Office Action Summary

09/822,154

IMMERMAN, ROBERT A.

FINAL ACTION

Des. 194,307
Patented Jan. 1, 1963

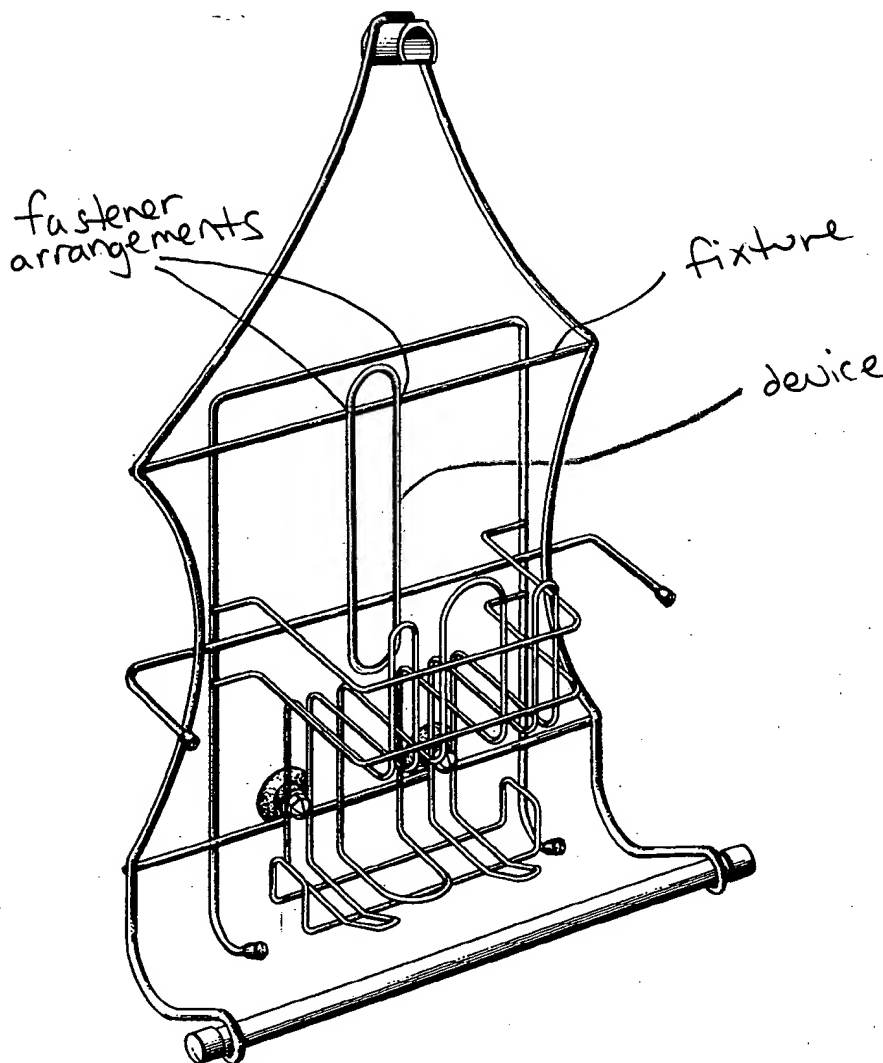
Claims 1 and 11 are rejected under 35 U.S.C. 103(a) as being unpatentable over Raphael (Des. 194,307). See attached drawing for details. Raphael shows an assembly comprising a fixture and a device comprising a first pair of generally parallel rigid wires traverse to a second pair of generally parallel rigid wires, which are co-planar with the first pair of wires, defining an opening and at least two fastener arrangements for fastening the device to the fixture. The suction cups shown have compressible heads attached to a neck with the neck attached to an engagement member. The heads are shown to be insertable into the openings made by the wires. The device can be interpreted as "generally rectangular" and it would be obvious to make it rectangular with the wires all being straight and 90 degrees to each other as most of the angles in the rest of the fixture are 90 degree angles and since it would not change the utility of

the invention. The suction cups can be inserted into any of the openings including the opening created by the device. Therefore it would have been obvious to one of ordinary skill in the art at the time the invention was made to make the device rectangular since the opening created when the device is attached to the fixture is rectangular and it would also be obvious to place another suction cup into that opening for added stability.
